OVERLAND FLOW REPORT STAGE 1

PROPOSED DEVELOPMENT: MAMRE WEST PRECINCT ORCHARD HILLS NSW

Project Title	Mamre Road, Erskine Park
Document Title	Overland Flow Report – Stage 1
Project No.	12042.00
Description	Overland flow assessment for new industrial development.
Client Contact	Mr Tim Ireson, Hansen Yuncken

8. PEER REVIEW

TUFLOW AND RMA-2 MODEL COMPARISON

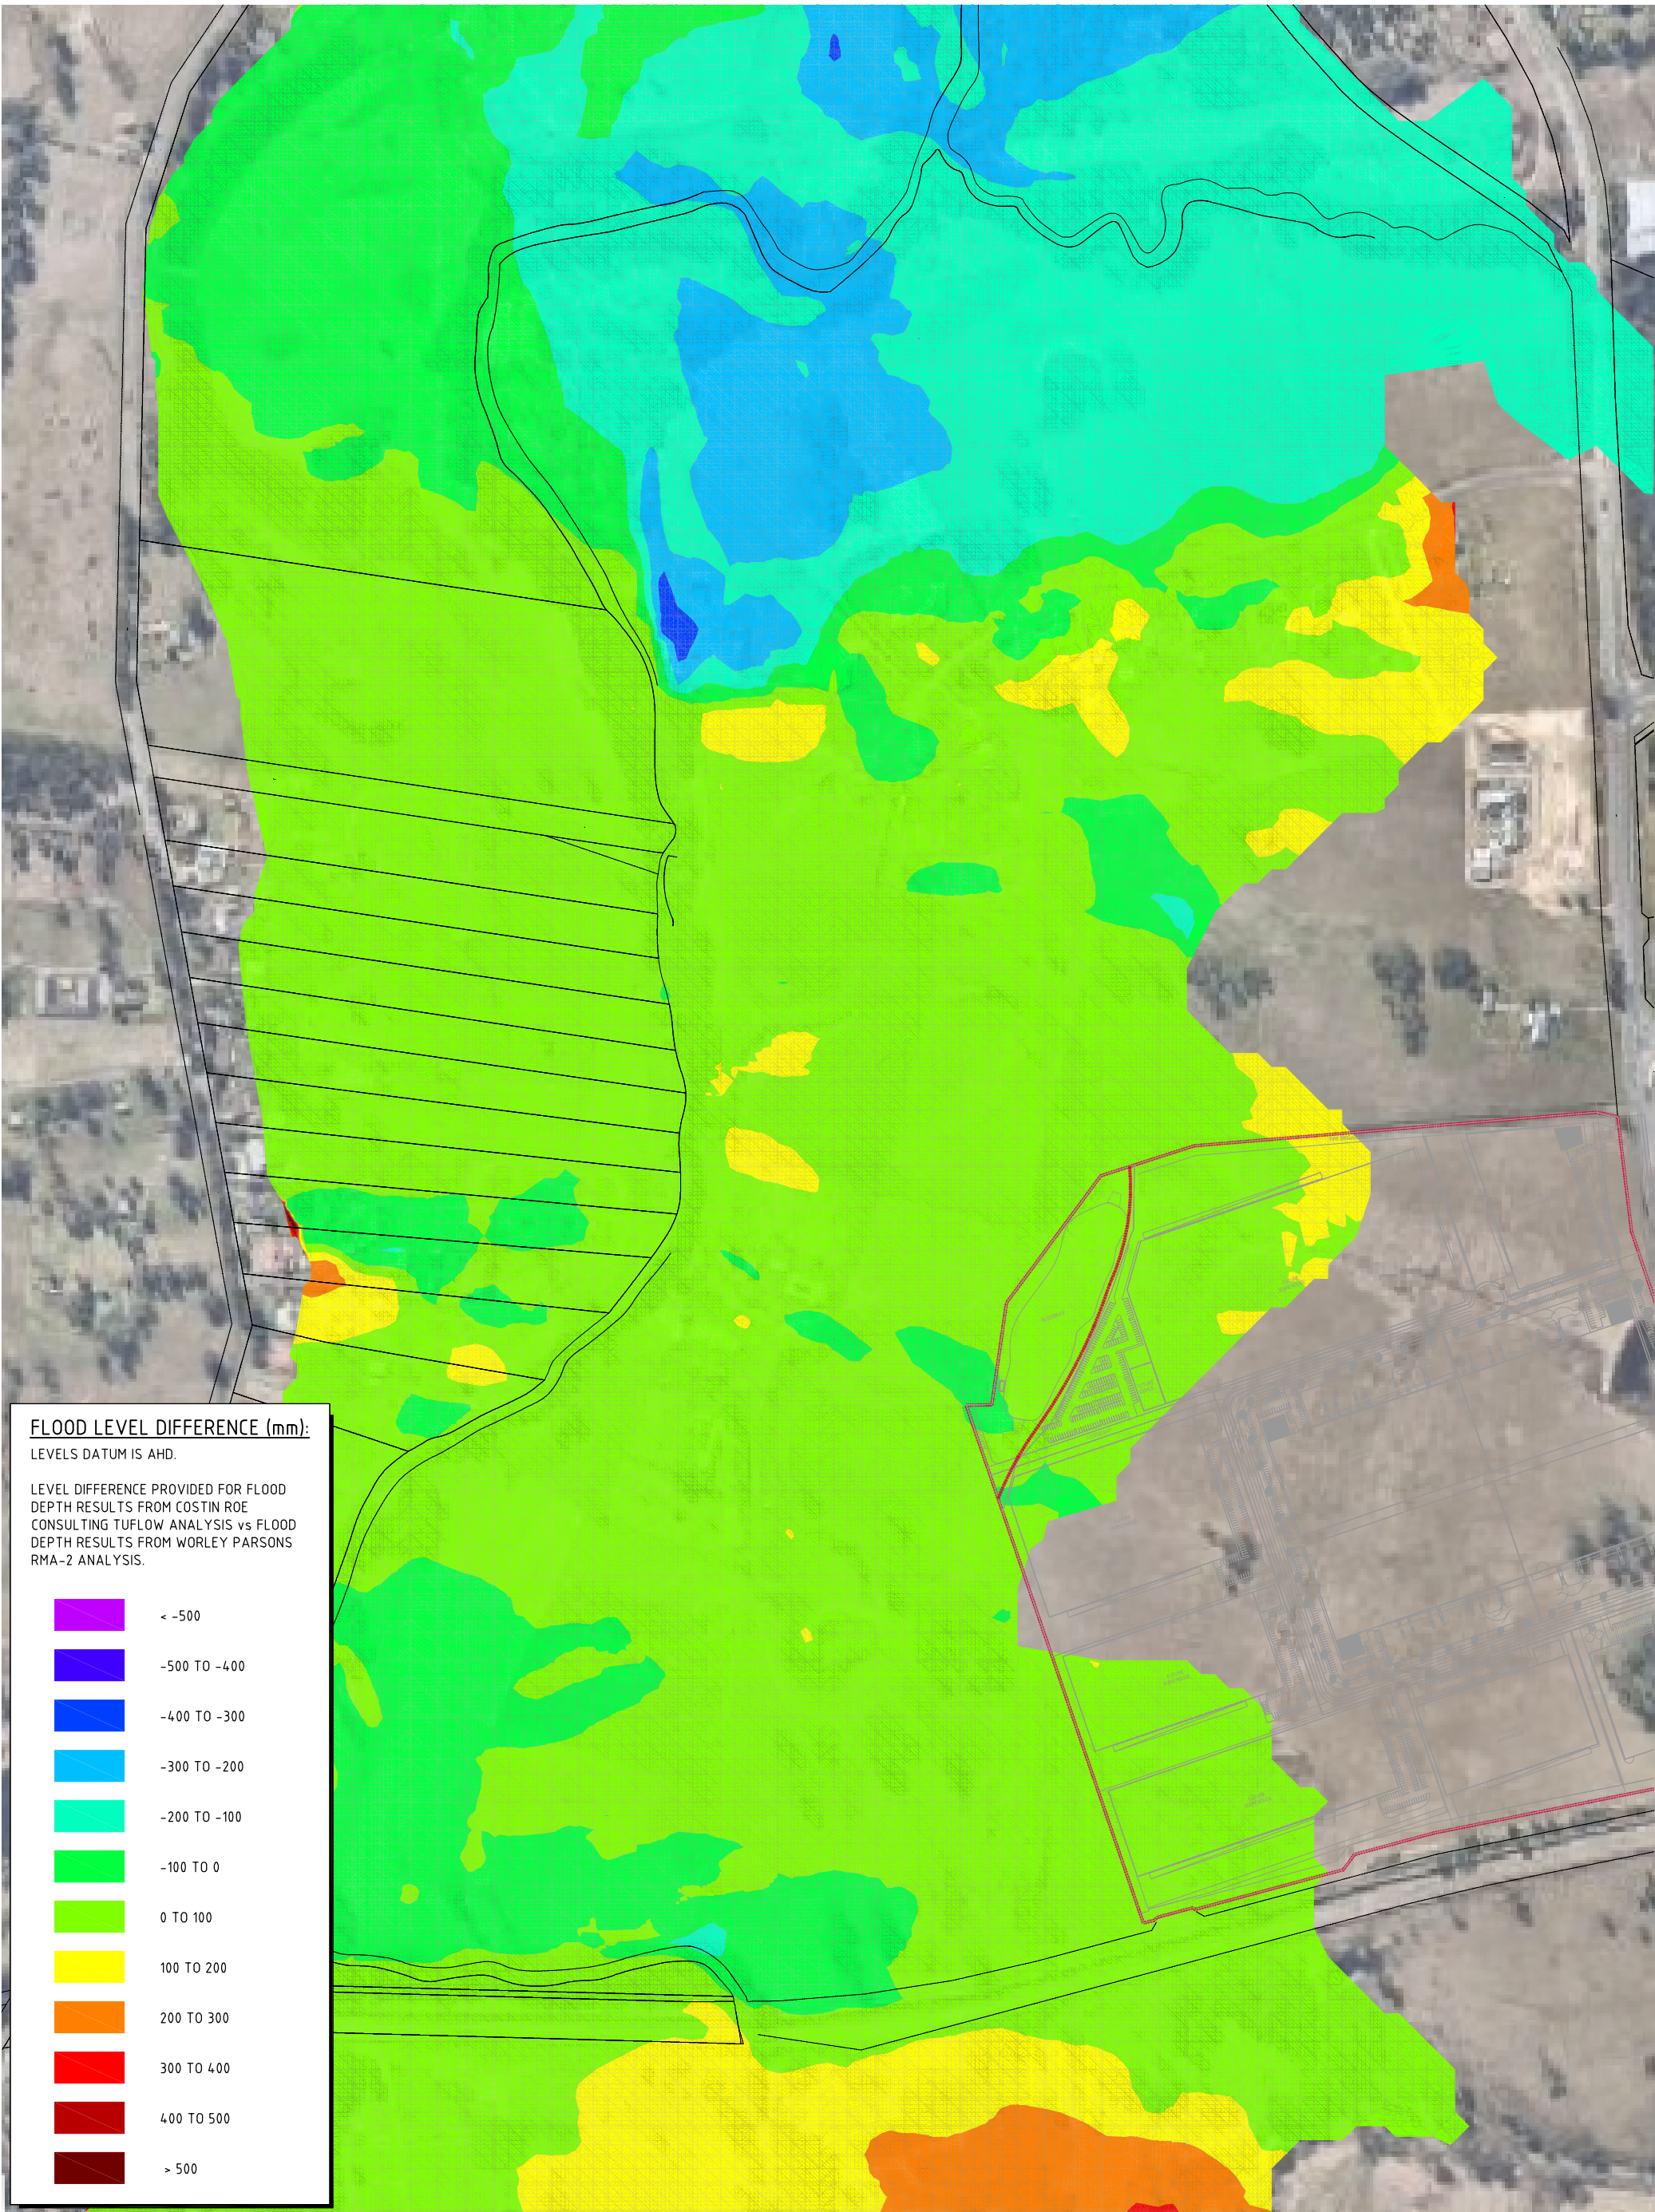
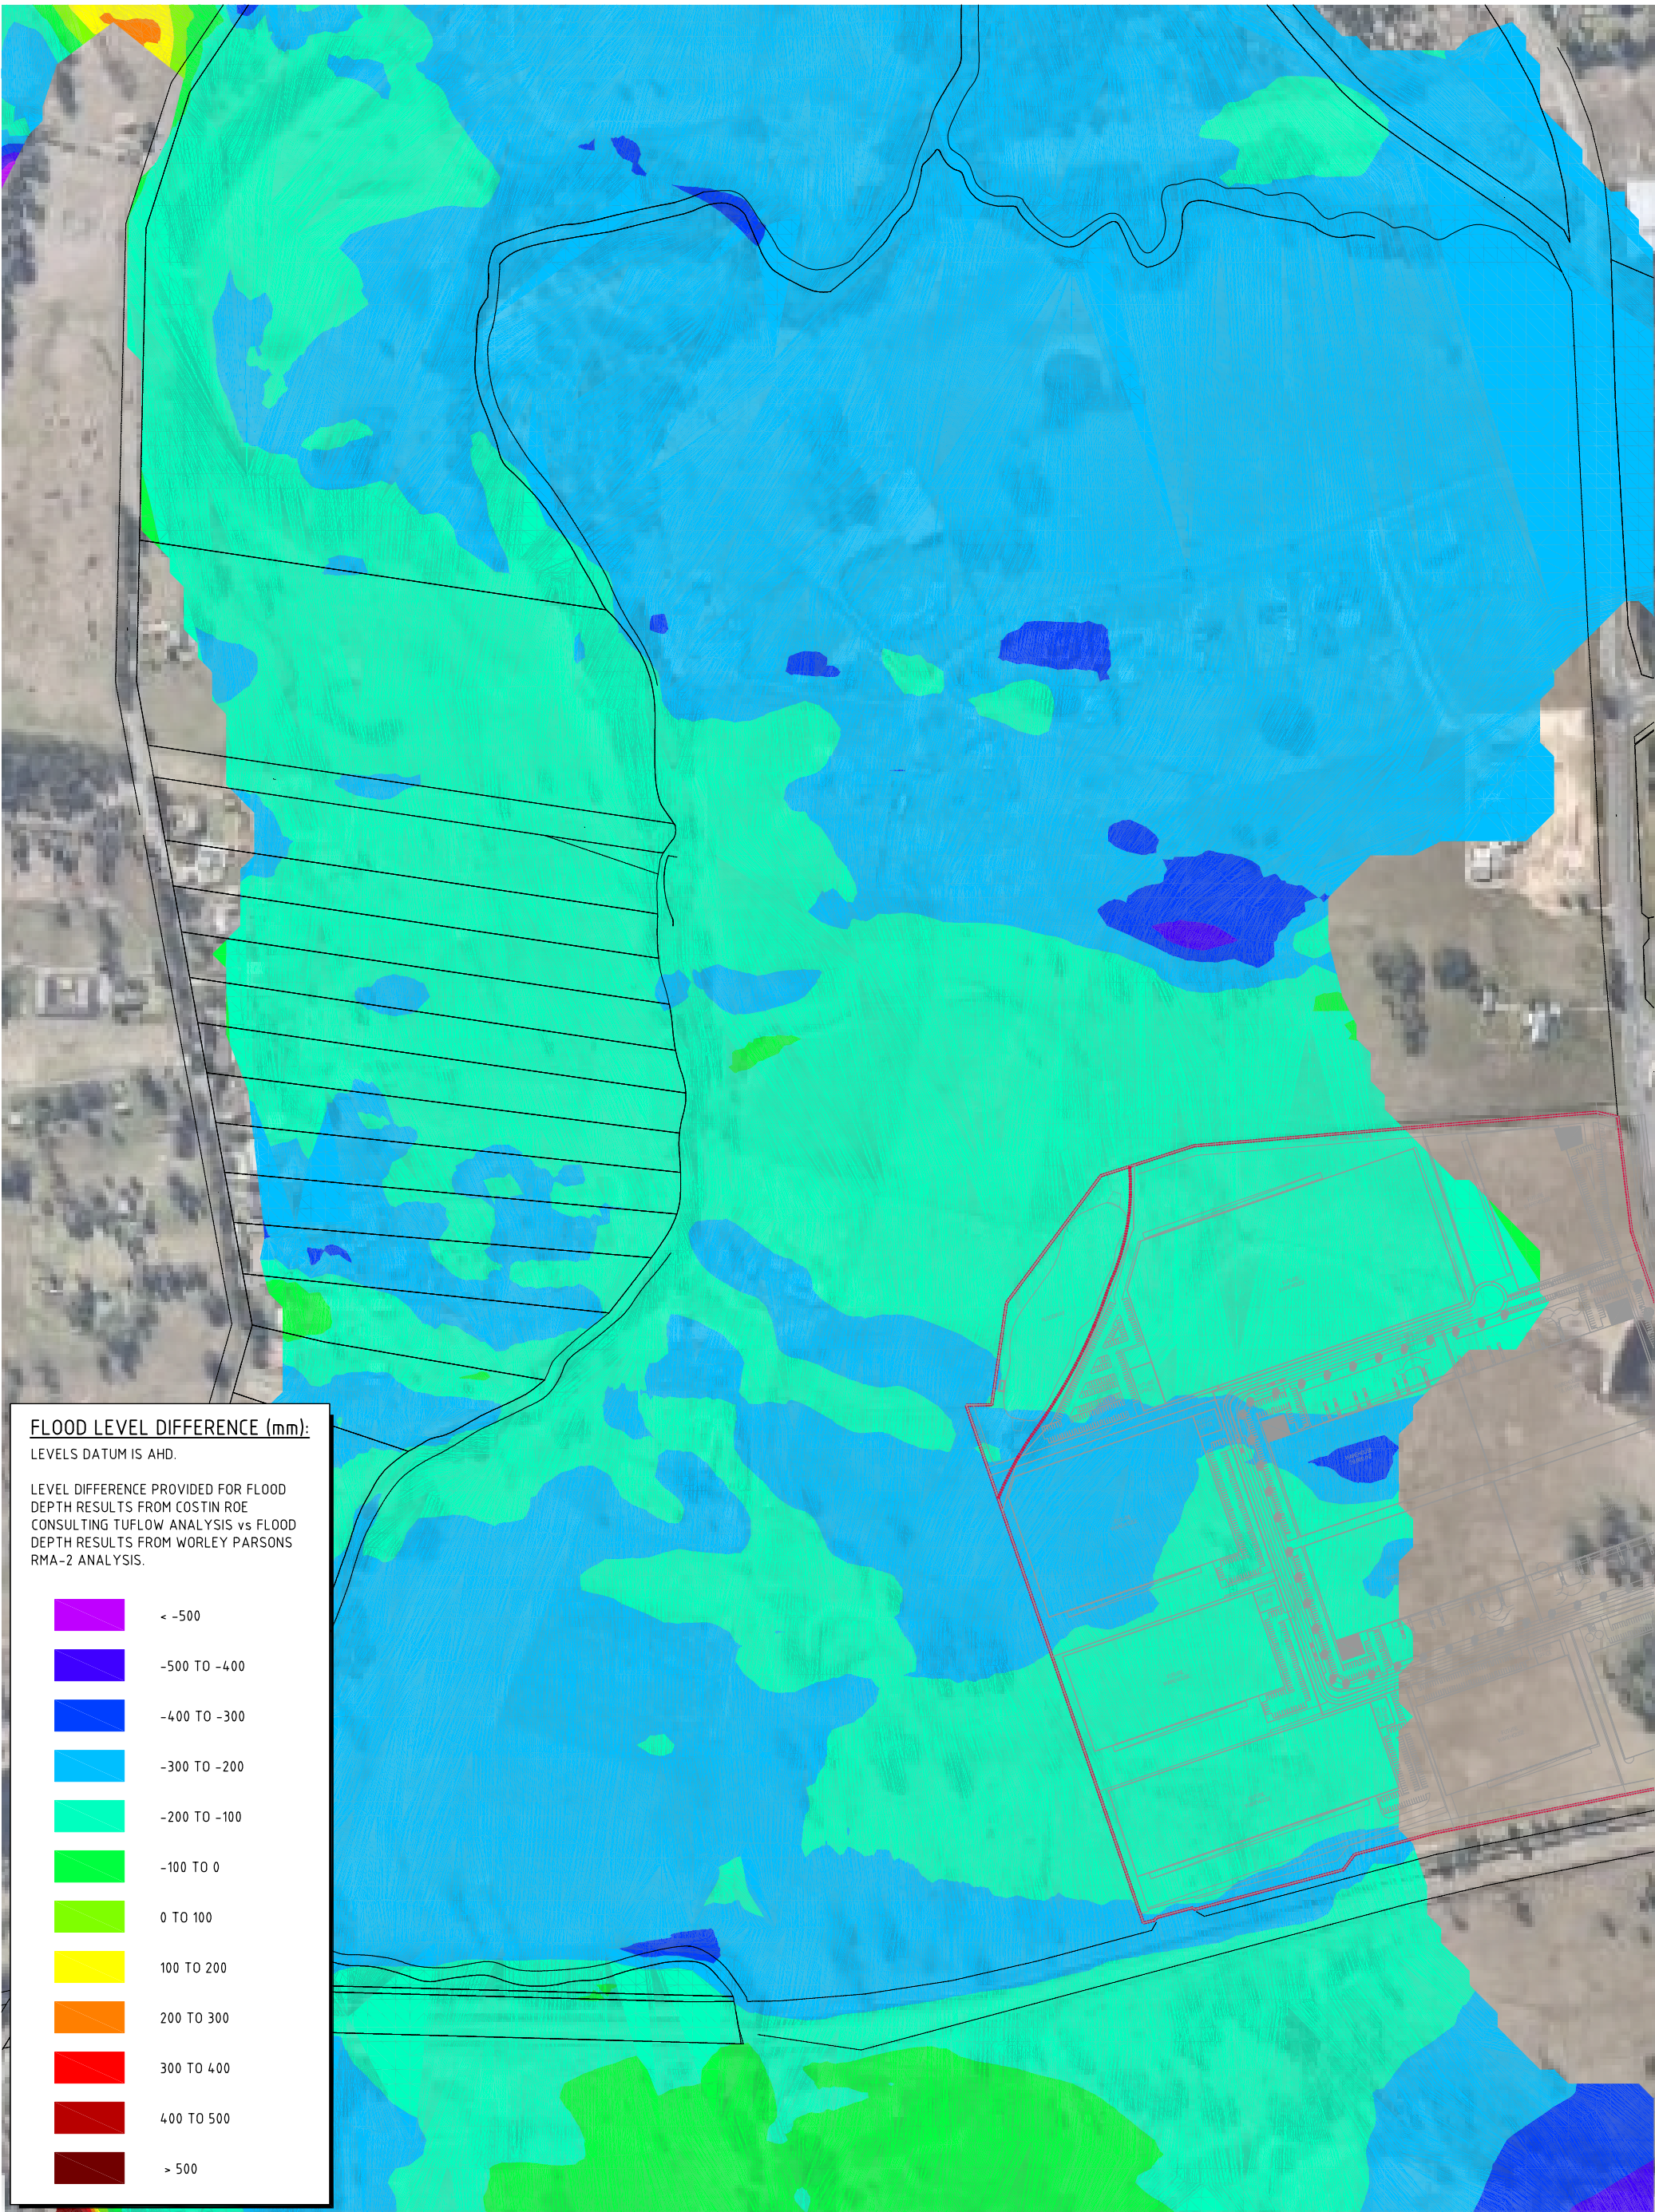
- Item B3 The TUFLOW and RMA-2 results documented in the South Creek Flood Study (Final, 2015) should be compared based on peak flood levels and not depths. Any differences should be presented and discussed similar to Section 3.2.1 and Figure 3 to Figure 6.*

Model comparison results have been adjusted to show differences in flood surface levels rather than flood depths. Please refer to **Appendix B** of the report.

INFLOW HYDROGRAPHS

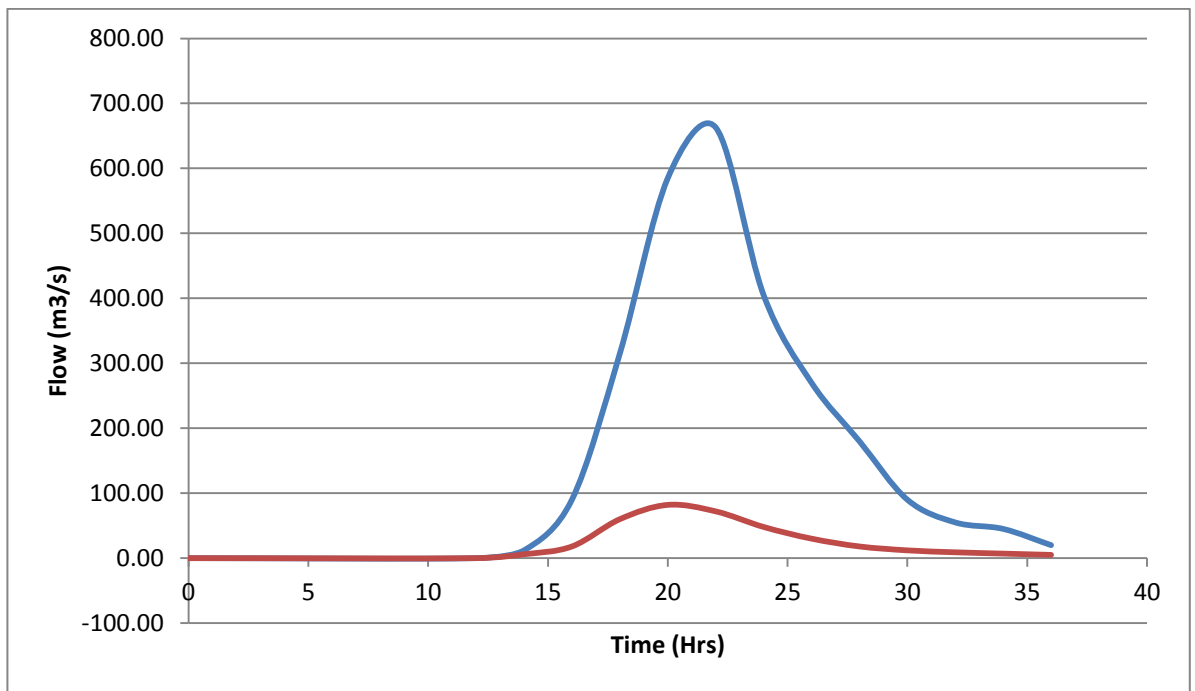
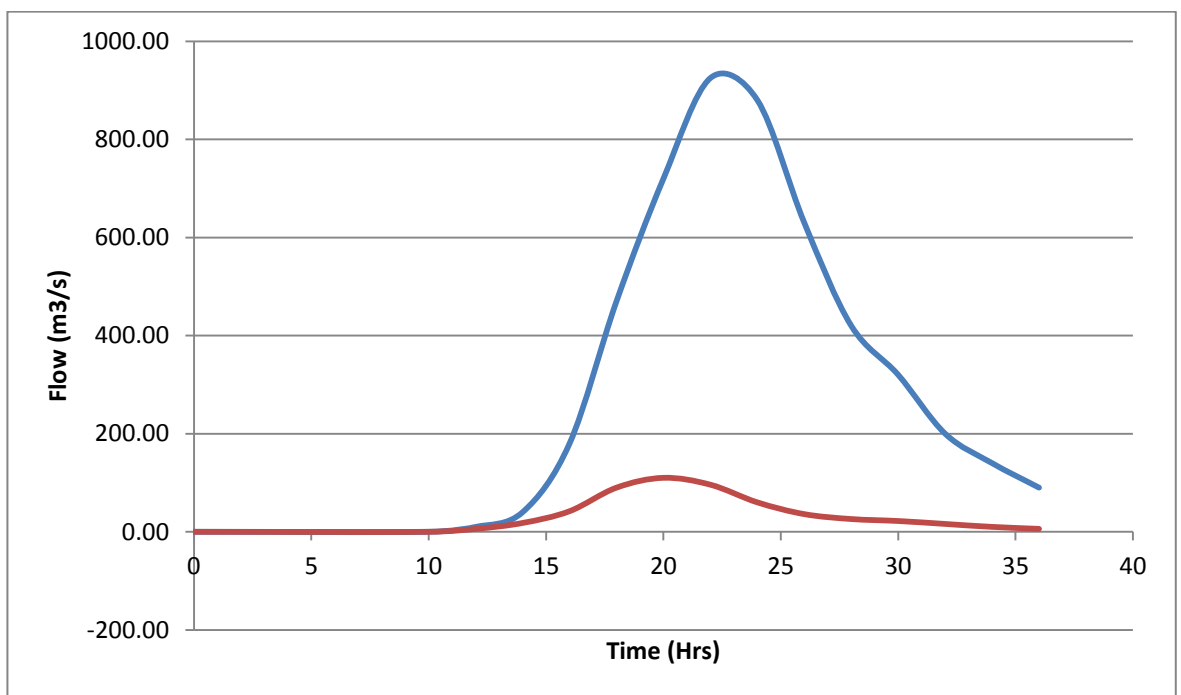
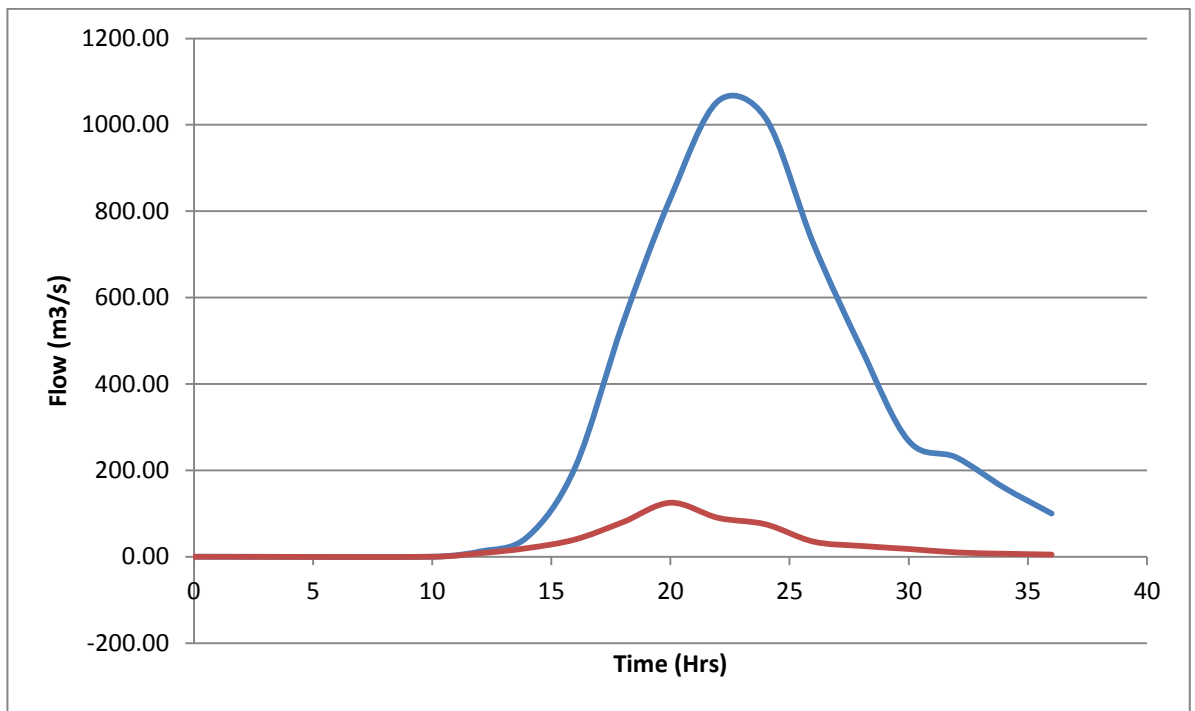
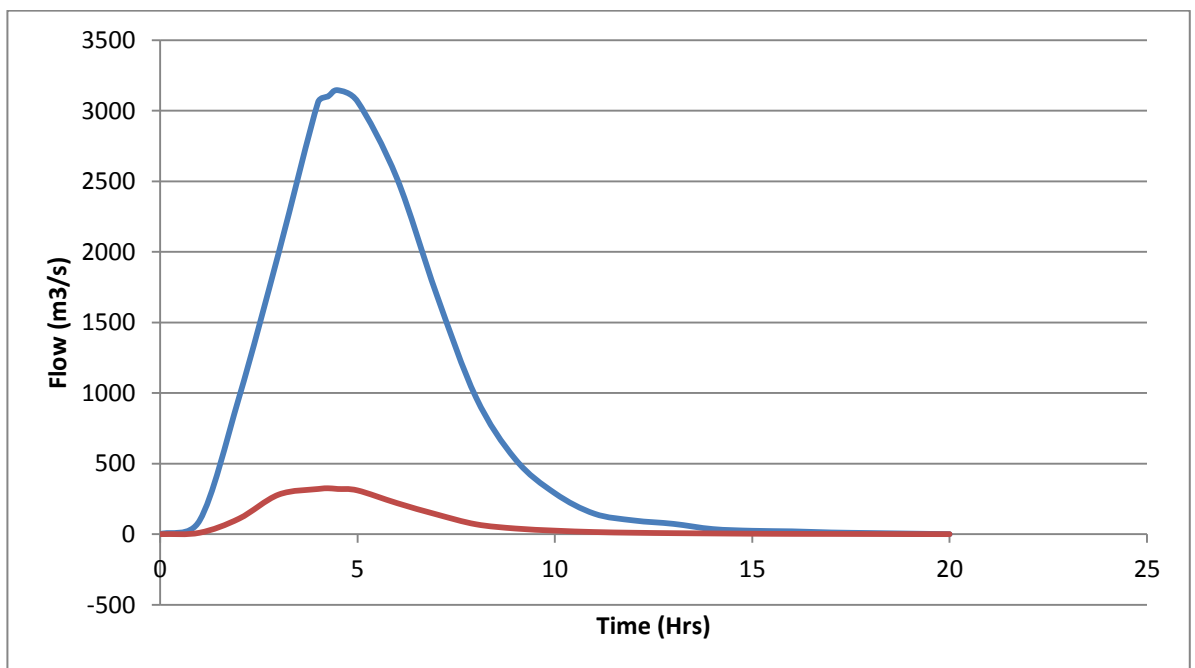
Item B1.d) Hydrology should be based on the flows from the RMA-2 model. The basic two-node RAFTS model is not considered satisfactory for the definition of flows and has been shown to predict lower flows for most design events (refer Table 2).

Inflow hydrographs have been adjusted to match those recommended in Table 2 of Worley Parsons Peer Review Report. Refer to **Section 5.2** and **Appendix C** of the report.
